REMARKS

Corrected Drawings

# ANNOTATED MARKED-UP DRAWINGS

26/46

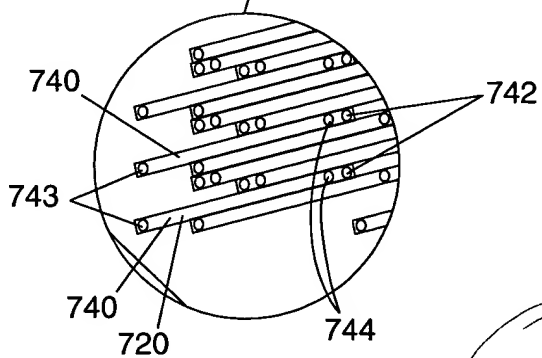
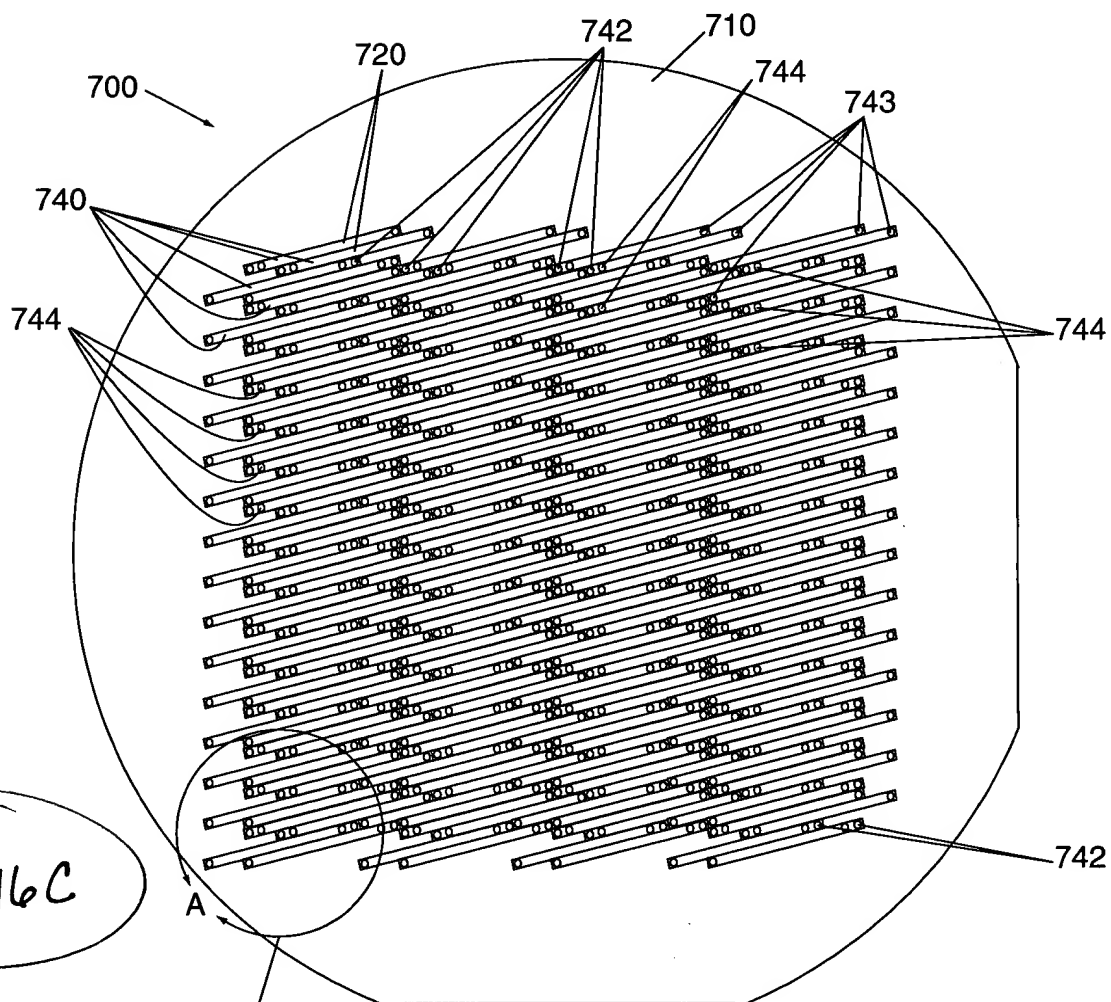
Applicants have submitted new Replacement Sheet for drawing sheet 26/46 that corrects the formal drawings – separately labeling the two views thereon as Figure 16C and Figure 16C-1. A marked-up version showing the changes to this sheet is also attached hereto labeled as “Annotated Marked-Up Drawings”. Applicants are also submitting a complete set of formal drawings, filed herewith, which include the corrected version of sheet 26/46. No new matter has been added.

Applicants have amended the specification to appropriately refer to each of the two views as now shown on replacement sheet 26/46 (submitted herewith and including Figure 16C and Figure 16C-1). Applicants have also amended the Specification to include the new corrected drawing sheet 26/46. No new matter has been added.
